## Product Change Notification (PCN)

Product group:		SEMIPACK	Rev.: 0	
	No.: PN21-079	SEMIPACK 5 new material of the cap insulator	10 Nov 2021

**Subject of change:** Introduction of a new material for the cap insulator

SEMIPACK 5

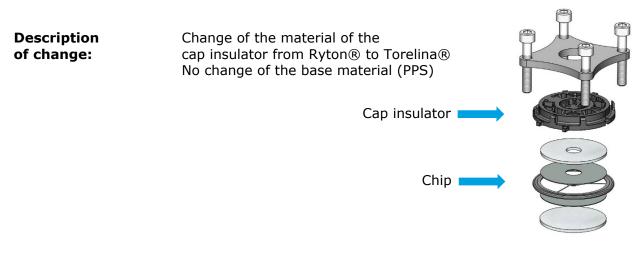
Reason for change: New supplier

Impact of change:No impact on form, fit, function and reliability of the modulesChange of Material Content Datasheet (MCDS)

Identification of change:	By date code
Time schedule for change:	Introduction planned from March 2022 onwards
Last time order date:	-
Last time delivery date:	-
Qualification:	Concluded and passed in accordance with SEMIKRON standards
Supporting documentation:	Qualification report and the draft of updated MCDS upon request
Author:	Kosiba, Rastislav
